STAFF REPORT

Conditional Use Review – New Modular Classroom North Albany Elementary School

FILE: CU-03-18

NORTH ALBANY ELEMENTARY SCHOOL SITE PLAN

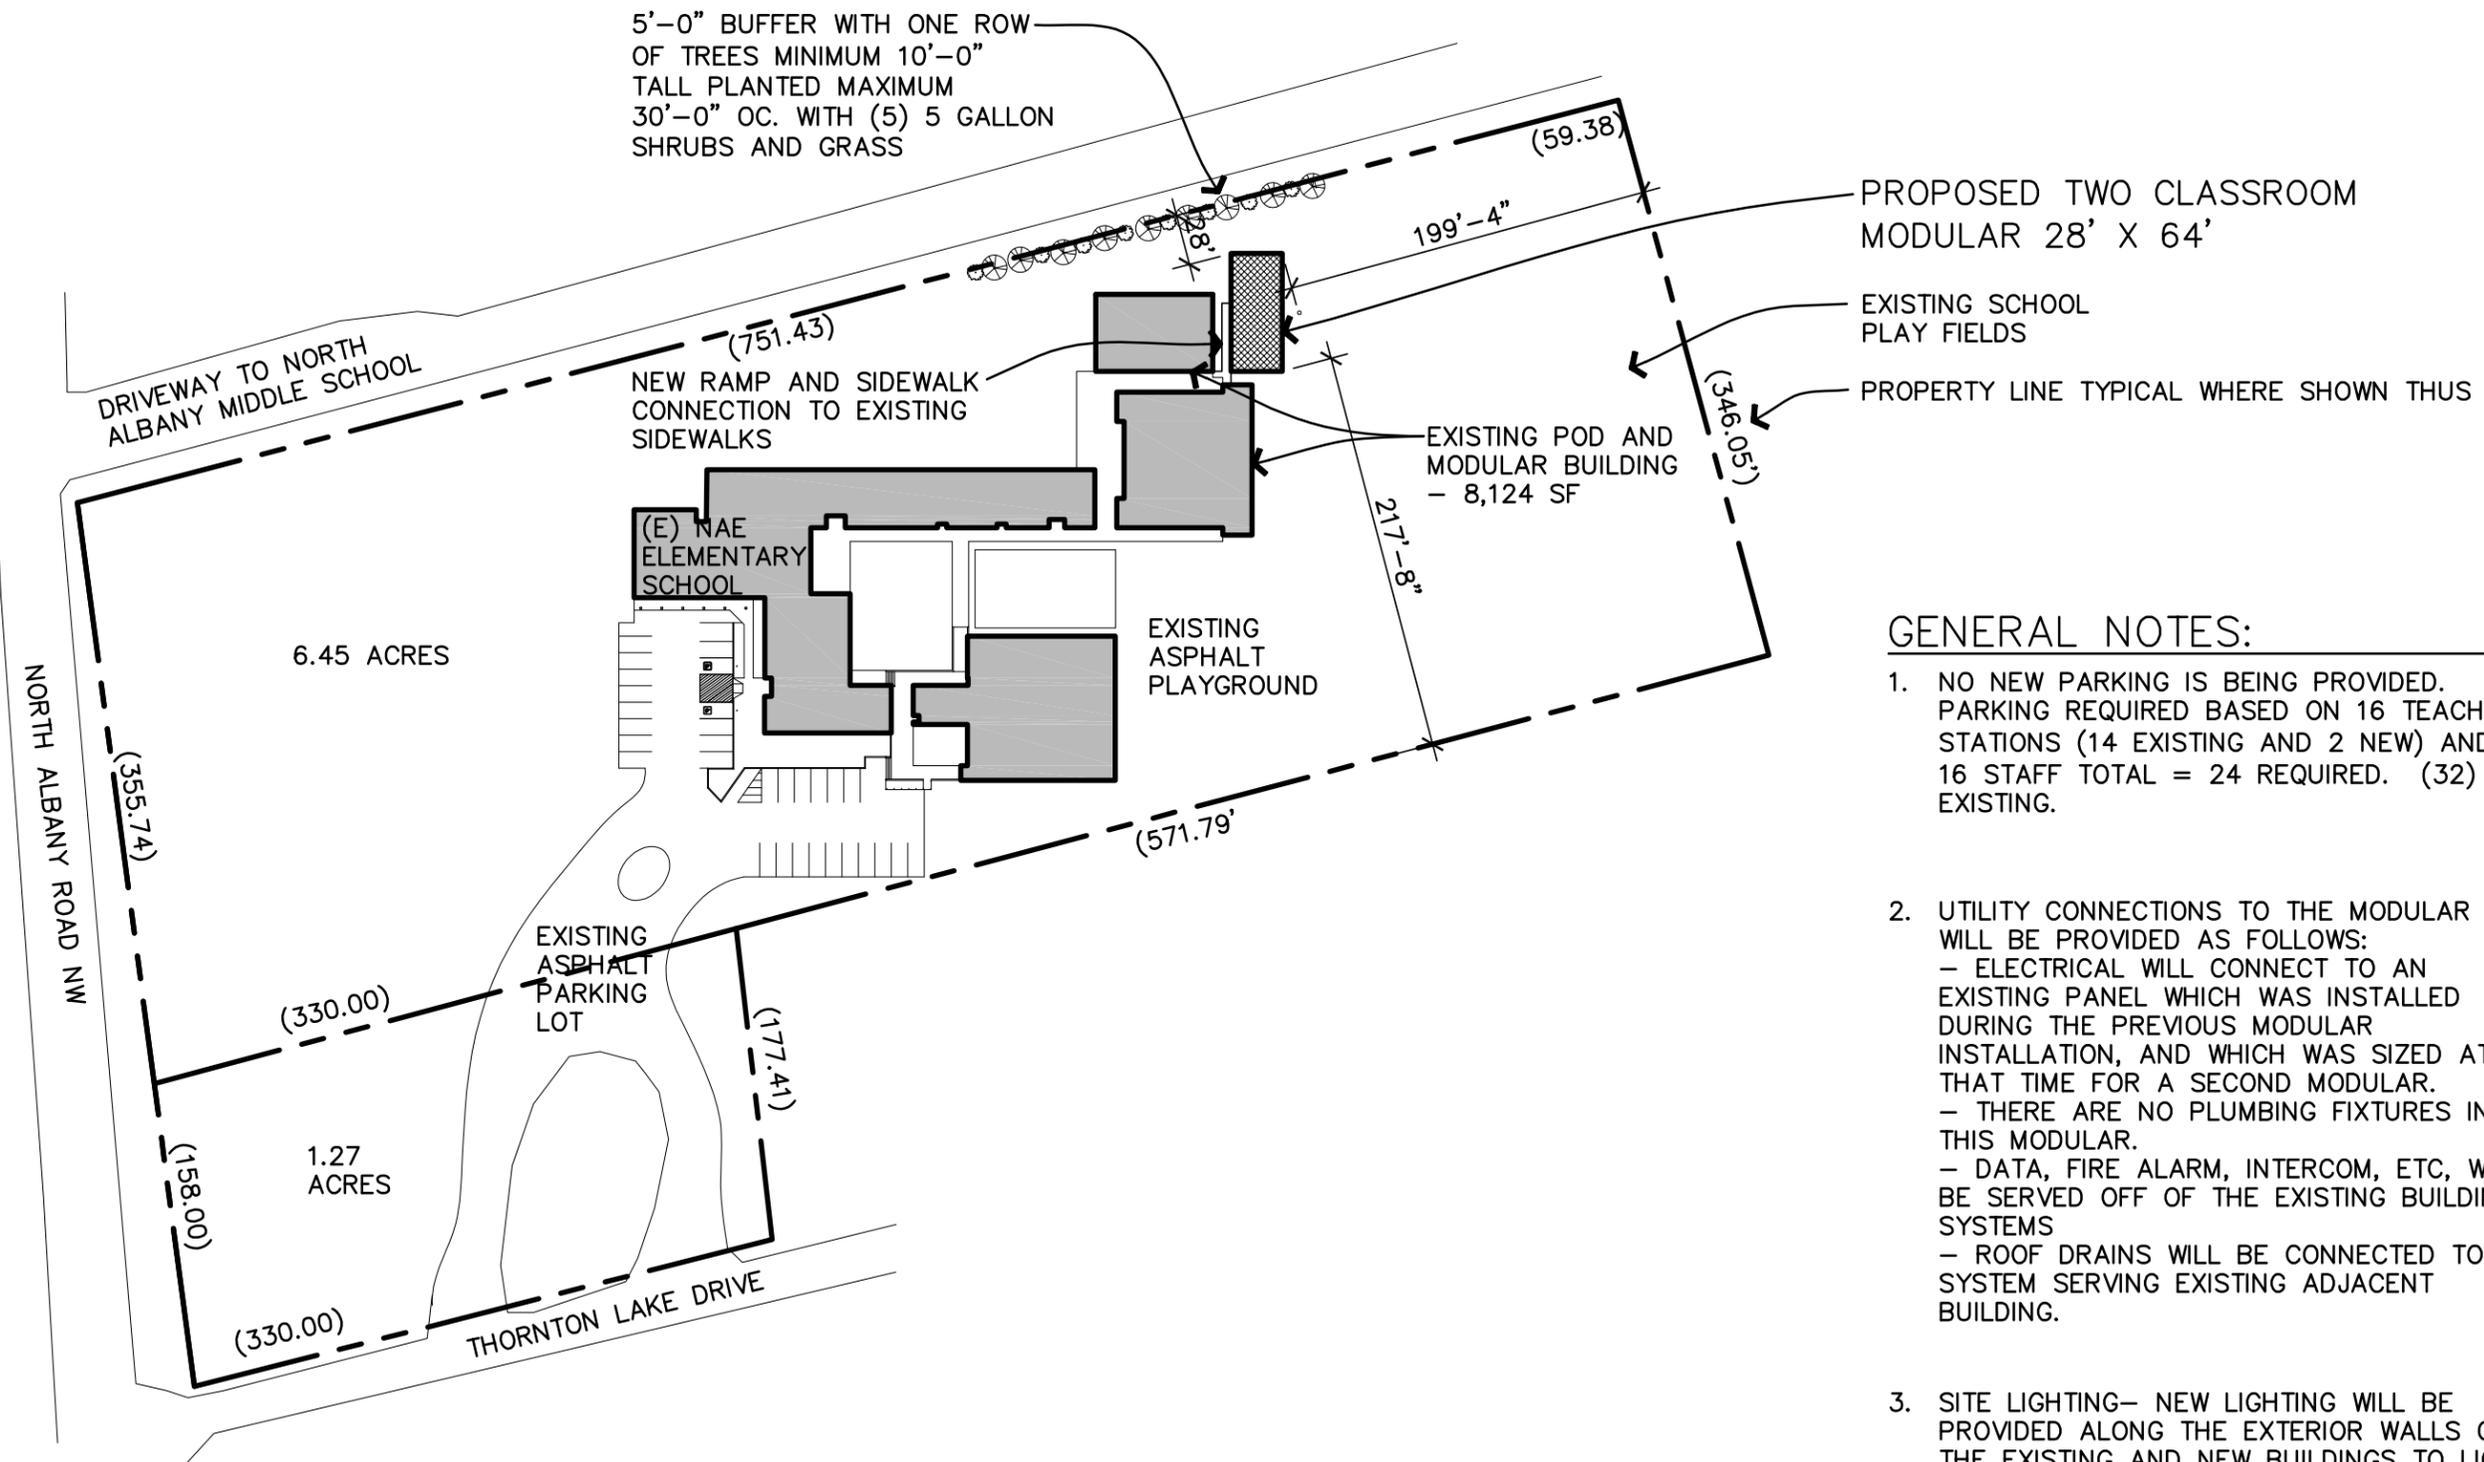
Although a detailed landscape plan and irrigation was not submitted, the site plan (Attachment C) shows a five-foot-wide, 200-foot-long buffer along the north property line with one row of trees a minimum of 10 feet tall planted, spaced a maximum of 30 feet on center with five five-gallon shrubs and grass ground cover.

- 6.4 According to the FIRM the applicants Site Plan (Attachment C), the proposed modular classroom will be located entirely outside of the 100-year floodplain, where the ground elevation is a minimum of 205.4 feet (NAVD '88) or higher.

1. Landscape buffering shall be provided between the northern property boundary and the proposed modular building, in accordance with ADC 9.240. As proposed on the site plan, landscaping shall include a five-foot-wide, 200-foot-long buffer with one row of trees a minimum of 10 feet tall planted, spaced a maximum of 30 feet on center with five five-gallon shrubs, and grass ground cover.
2. The required buffer shall be provided with a piped underground irrigation system unless the applicant submits written verification from a licensed landscape architect, landscape construction professional, or certified nurseryman that the proposed plant materials do not require irrigation.

3. Prior to issuance of a building permit, the applicant shall submit a landscape plan, and irrigation plan (as needed), for Planning Division verification of compliance and approval.
4. Prior to issuance of a certificate of occupancy, the applicant shall complete the installation of required buffer landscaping and irrigation (if any) in accordance with the approved landscape plan.
